CITY OF ALBUQUERQUE

July 29, 2020

RE: **Lot 11 Block 9 Volcano Cliffs Unit 22 SAD 228**
6405 Petirrojo Rd. NW
Grading and Drainage Plan
Engineers Stamp Date 6/26/2020 (D10D003Q11)
Pad Certification Date 7/27/2020

505-249-4843 donbriggseengineering@gmail.com 5324 Oakledge Ct. NW, Albuquerque, NM 87120	
TITLE: 6405 Petirrojo Rd. NW Grading & Drainage Plan			
Design Review Committee	City Engineer Approval	Last Design Update	Mo. / Day / Yr.
City Project No.	Zone Map No.	Sheet	Of

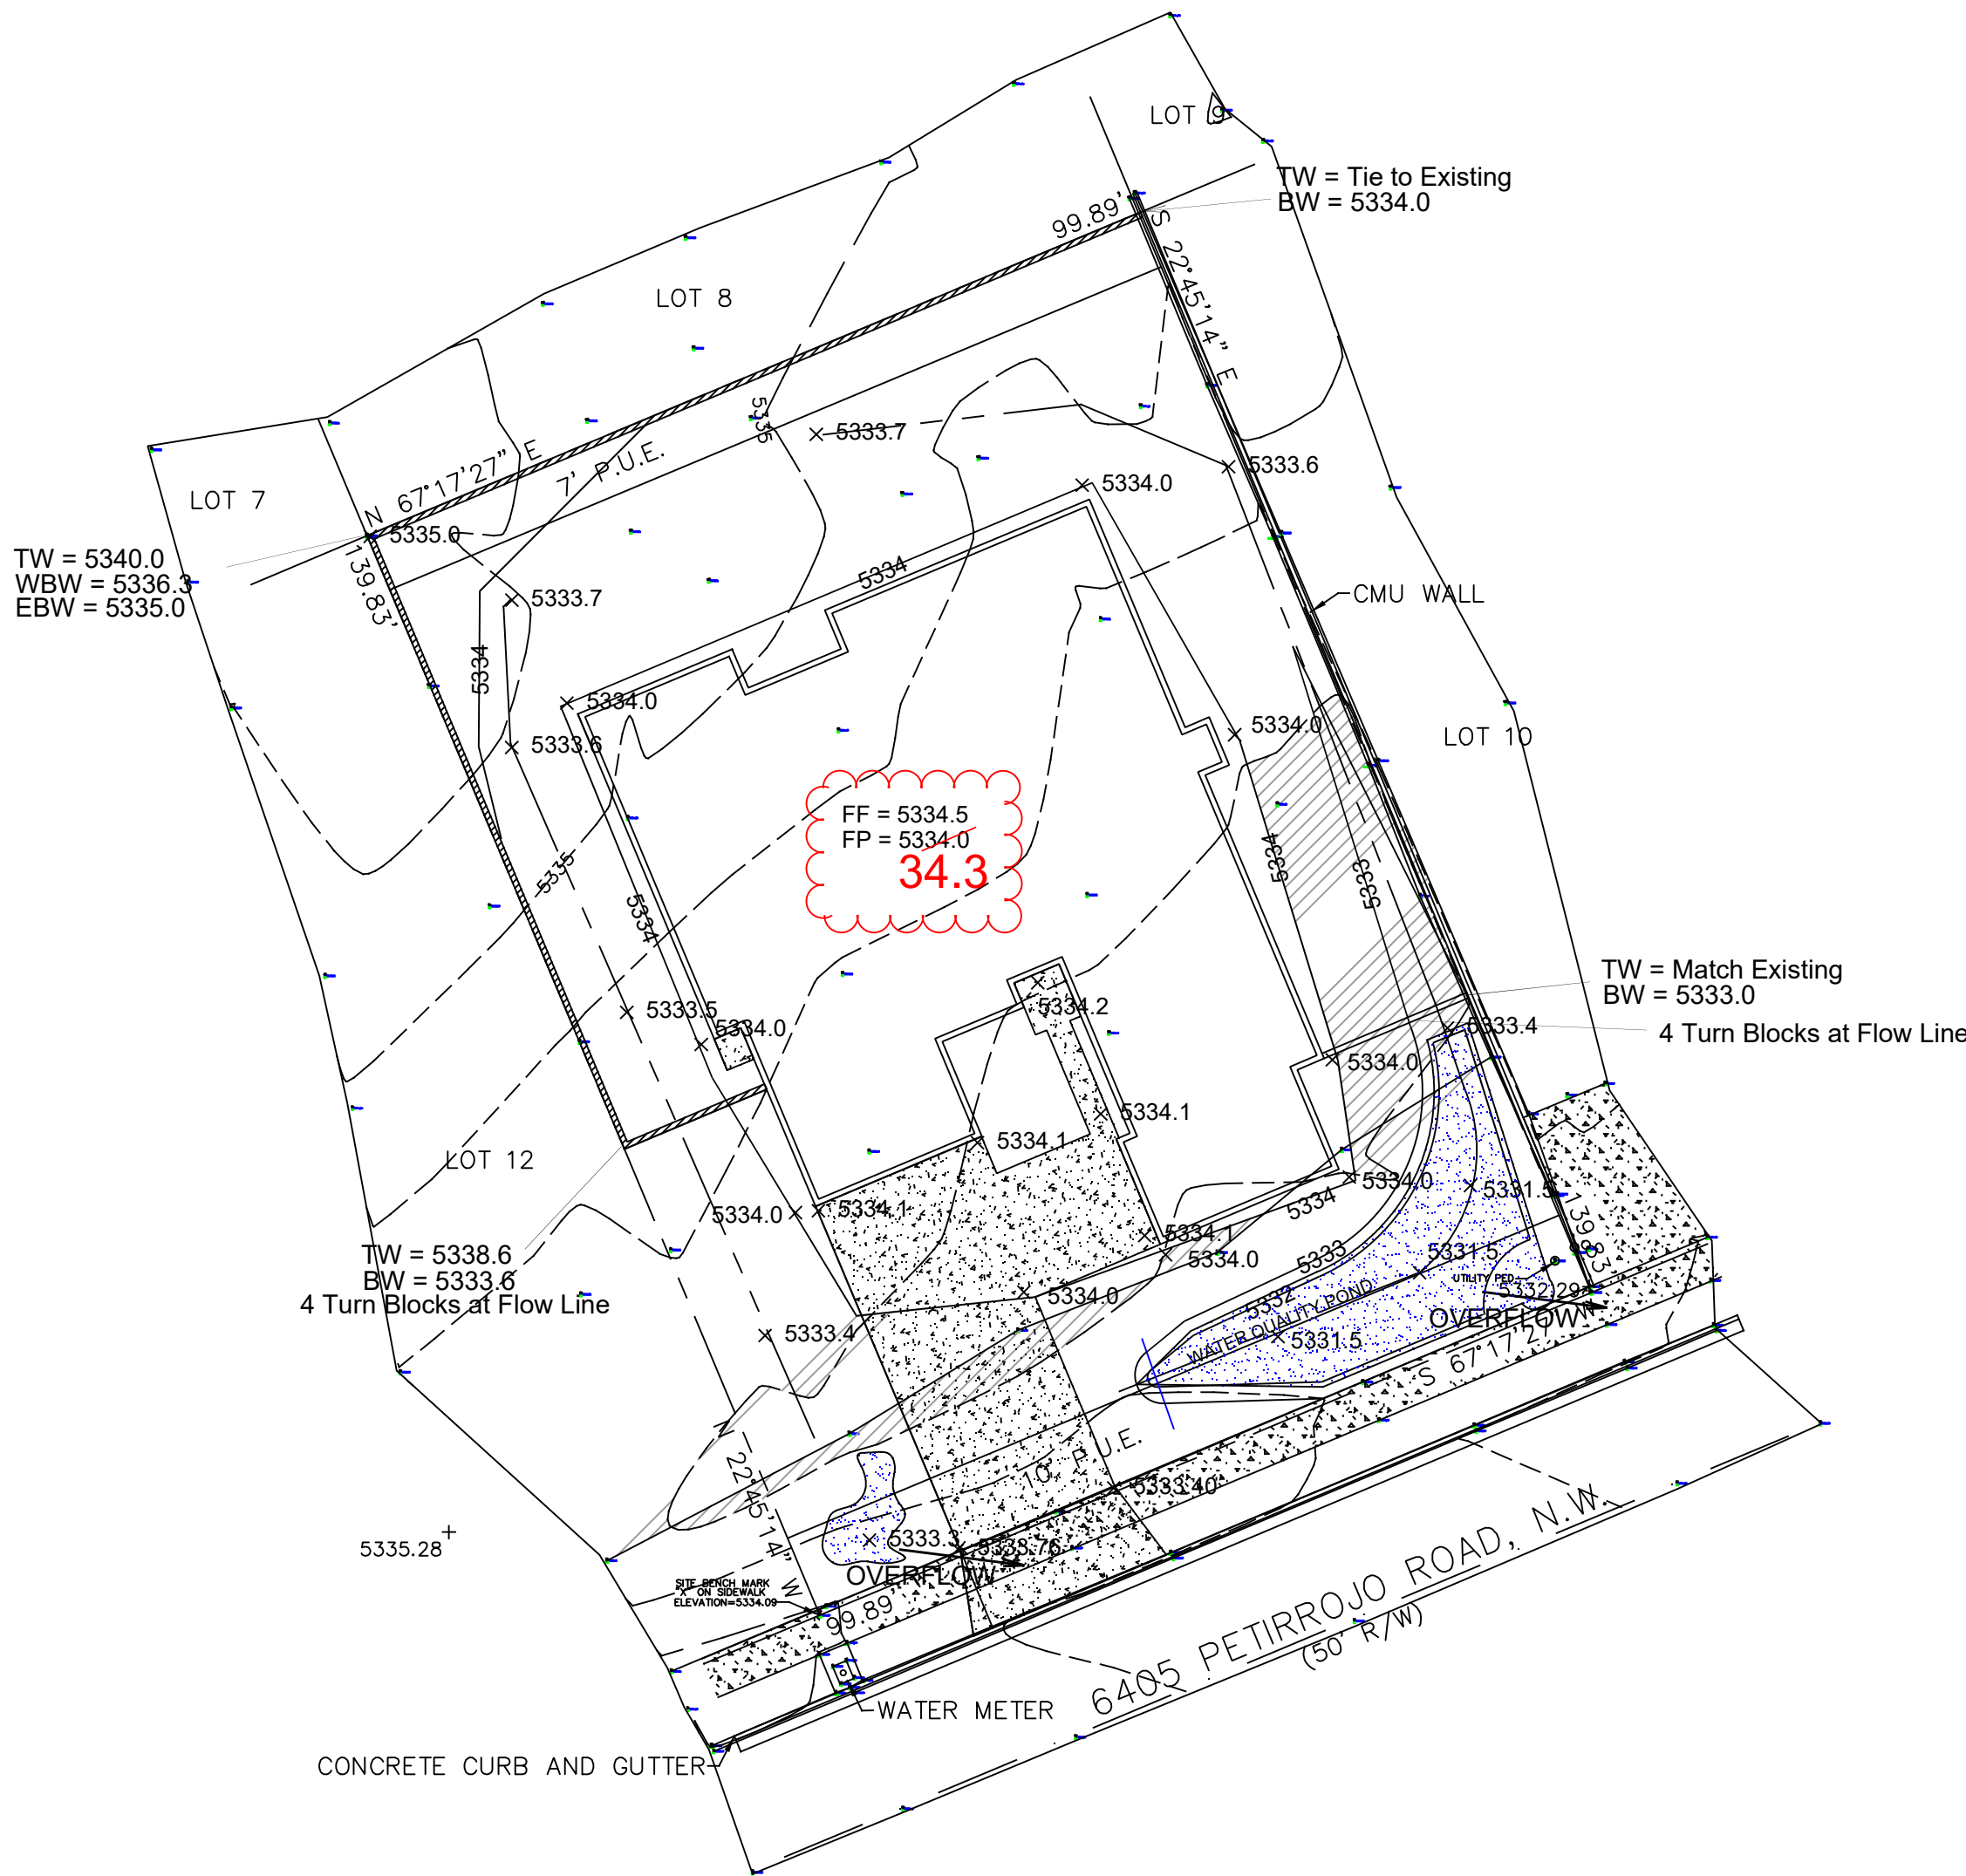
Based upon the information provided in your submittal received 7/28/2020, this plan is approved for Building Permit.

Reiterate to the Owner/Contractor that a separate permit for a garden/retaining wall must be obtained, with the approved G&D plan dated 6/26/2020 and Pad Certification Date 7/27/2020.

Prior to Certificate of Occupancy release, Engineer Certification per the DPM checklist of this plan will be required.
